Bellambi Gully Flood Study

APPENDIX D
PROPOSED MITIGATION MEASURES

Client	WOLLONGONG COAL LIMITED
Project	BELLAMBI GULLY FLOOD STUDY
Title	PROPOSED CULVERT AND SWALE SECTIONS AND DETAILS

Subject: FW: review of Bellambi Gully Flood Study for Russell Vale Colliery Site

APPENDIX E
PROPOSED SCENARIO HYDRAULIC
MODEL

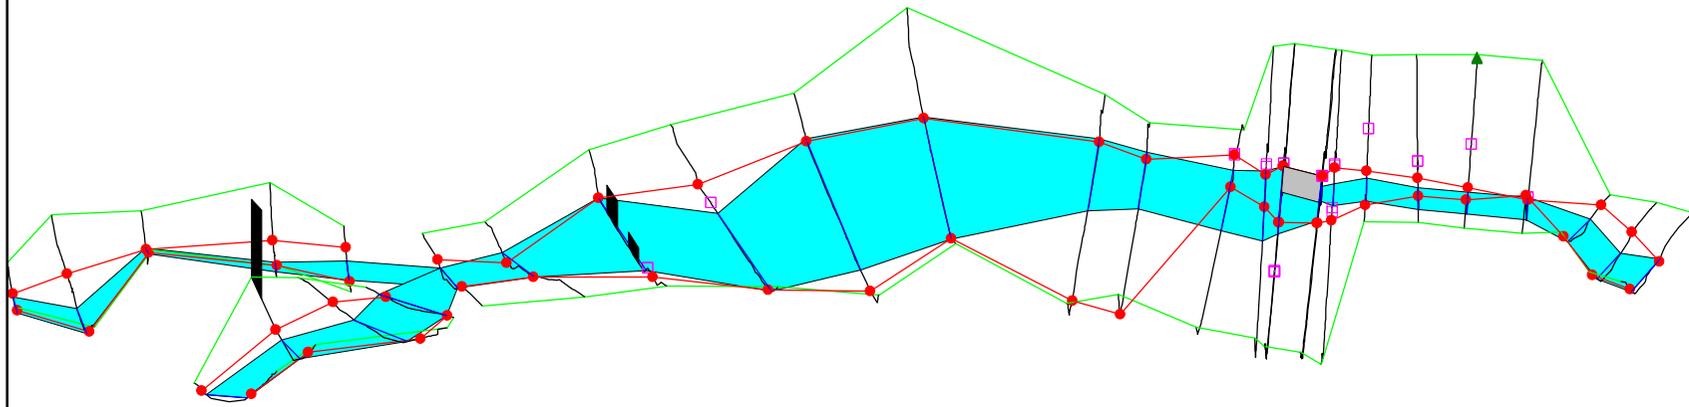
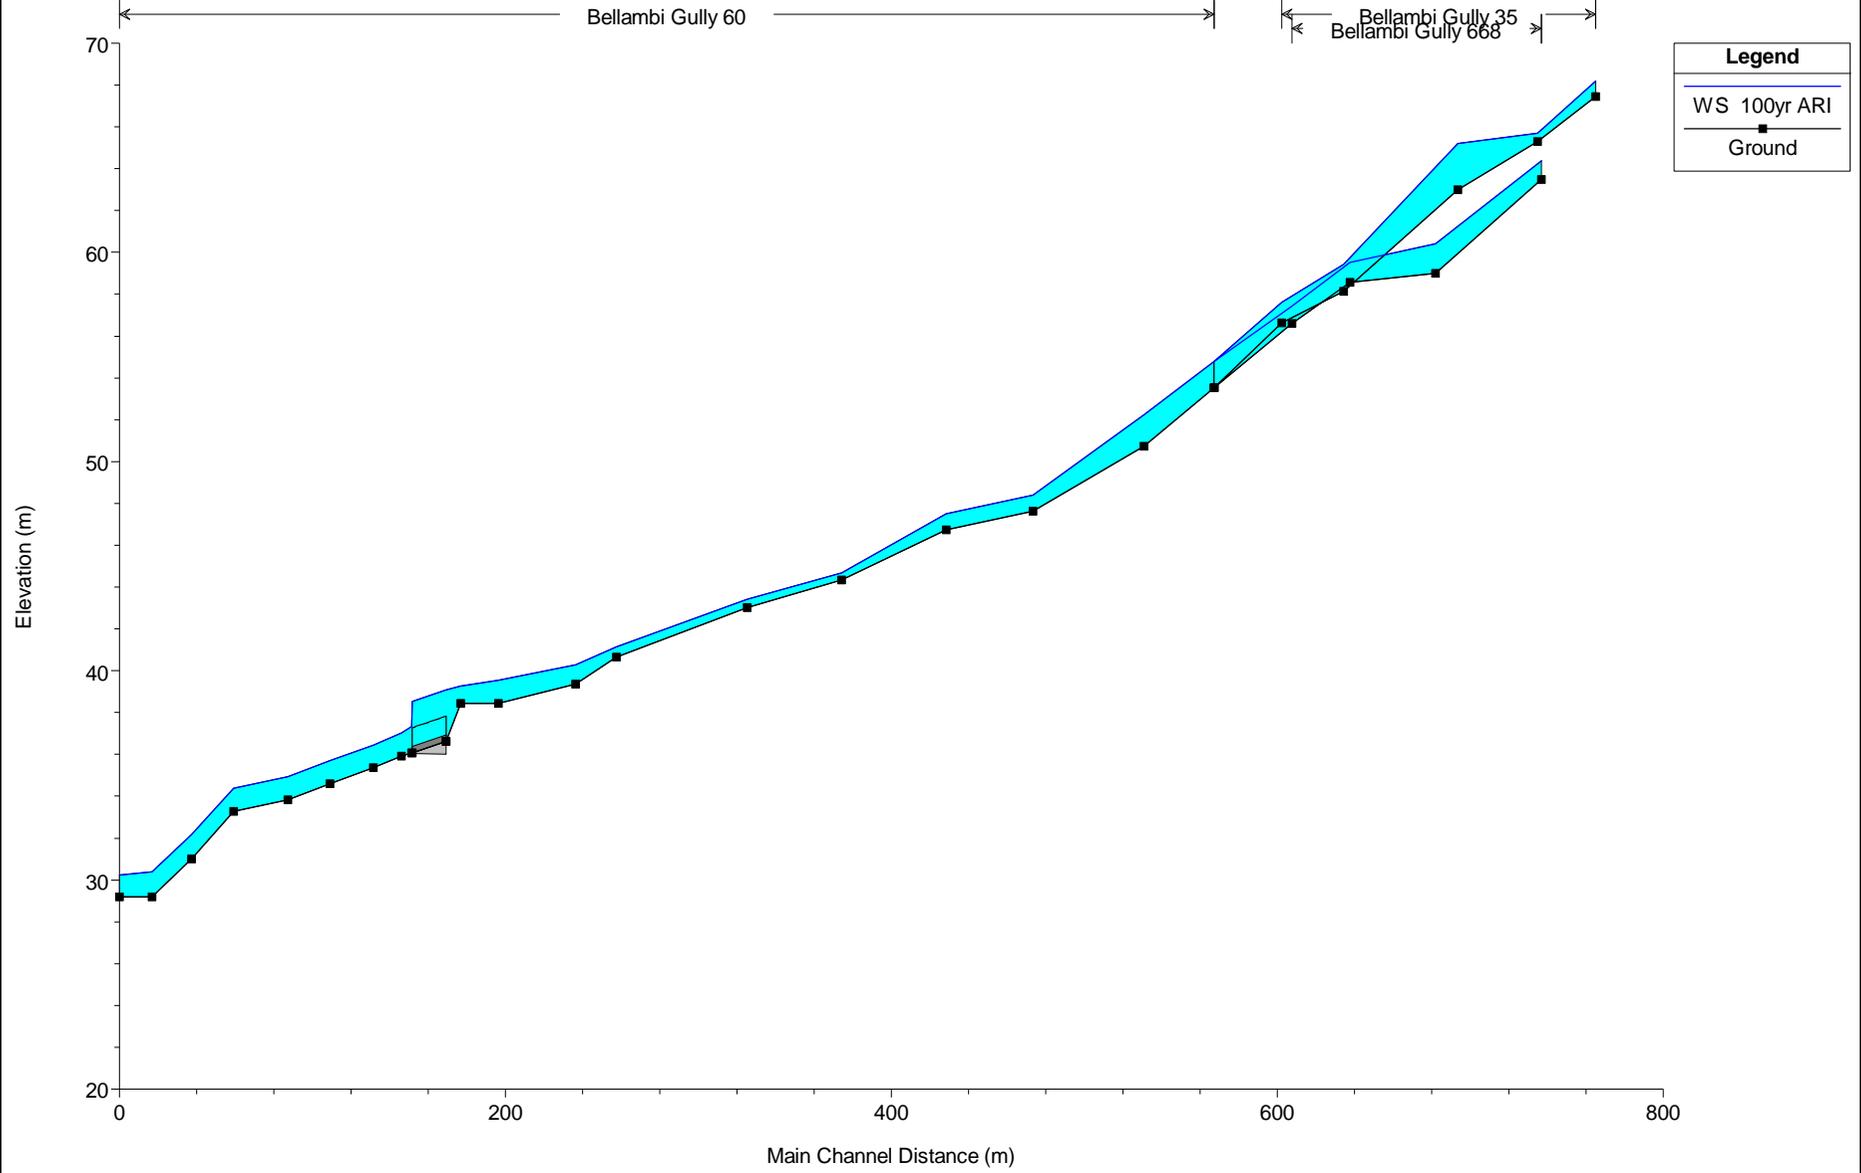
The proposed flood mitigation measures for the site should be accurately reflected within Appendix E of the updated study.

The revised report adopts Council blockage policy upstream of the 6m culvert, and increases the sag over the culvert to convey 100 year ARI flows overtopping the road in this scenario. Amended sections have been highlighted for reference.

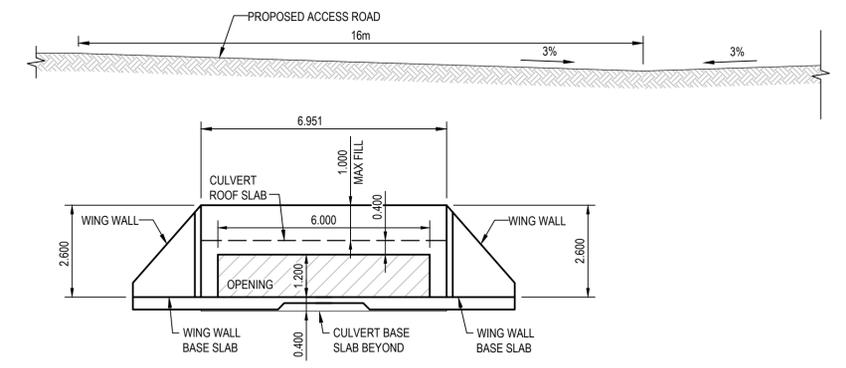
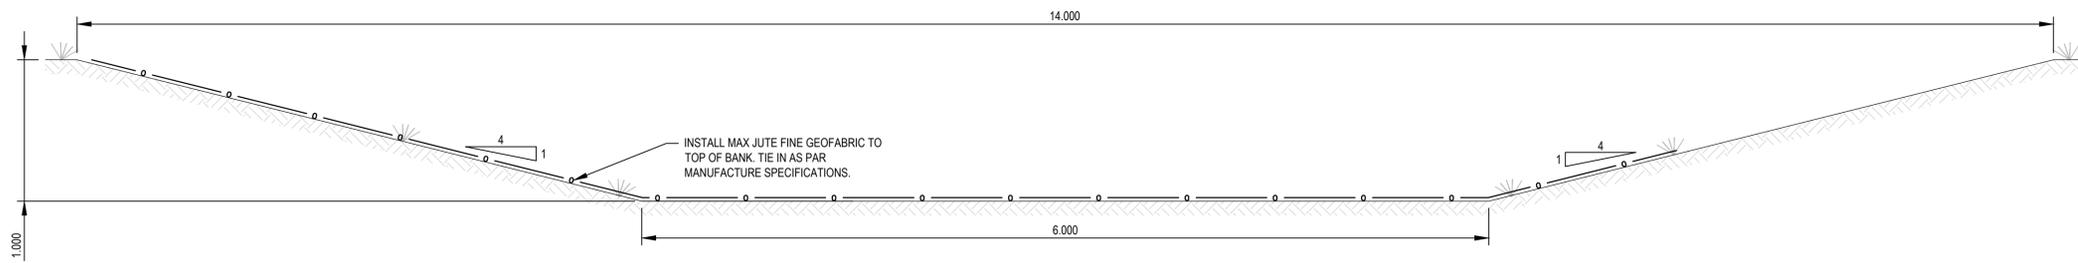
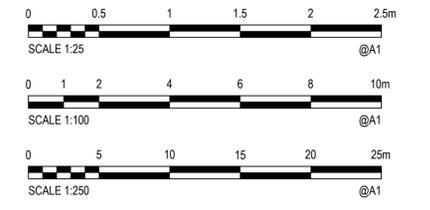
In order to address the concerns raised above, the proposed mitigation option for the site should be based on the Wollongong Council 'policy based' conduit blockage criteria. This approach adopts 100% blockage of all stormwater pipes having less than 6m diagonal opening and 25% bottom up blockage for stormwater pipes having greater than 6m diagonal opening. This would result in a culvert design of greater than 6m in diagonal located at the stockpile access road to cater for the contributing stormwater flows arriving on the site for a 100 year ARI event or greater. The proposed swale alongside the stockpile access road should also be designed to cater for the contributing 100 year ARI flows or greater to ensure these flows are conveyed to the licensed discharge point at Bellambi Creek.

Final dimensions of the proposed culvert and swale including calculations demonstrating the capacity of each in line with the abovementioned conduit blockage policy should be included within the study for further assessment.

It is considered that the previous flooding comments raised have now been addressed. In particular, the flood modelling has now considered all culverts <6m in diagonal as 100% blocked and (proposed) culverts >6m in diagonal as 25% blocked btm up. This has resulted in a proposed culvert 6m wide x 1.2m high under access road with low point in access road to direct overflows into proposed swale designed to carry the 100 year flows from the site.

With regards to the culvert sizing, we reviewed sizing of the 6m RCBC designed for the Ridge (as discussed), and found that 1.2m H was adopted following liaison / agreement with Council. On this basis we've adopted 1.2m H for this site also.
